NEW MEXICO OIL CONSERVATION DIVISION  
 - Engineering Bureau -  
 1220 South St. Francis Drive, Santa Fe, NM 87505

J.F. Harrison Fed #1

**APPLICATION FOR AUTHORIZATION TO INJECT**

**Re: Notice of Application for  
Authorization to Convert to SWD  
JF Harrison Fed #1  
Eddy County, New Mexico  
File: 100-WF: HarFed 1 Offsetownerltr**

**CURRENT WELLBORE DIAGRAM**

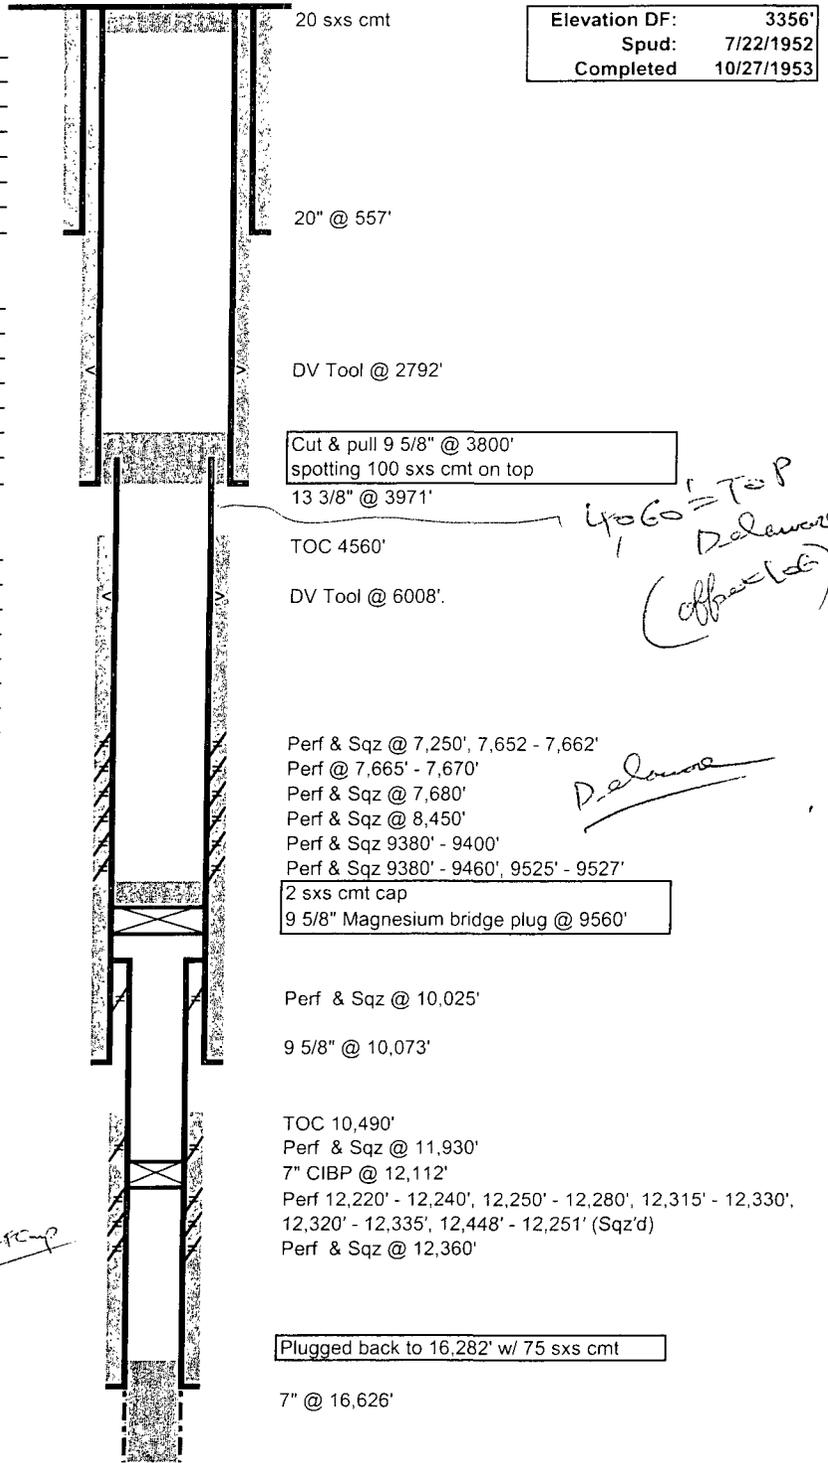
- d. The 7 inch liner is shown as extending from 9850 to 16626. The post conversion wellbore diagram shows tieback cement of the new 7 inch to approx 7000 feet. Is this correct? Is the 7 inch casing planned to extend to surface?
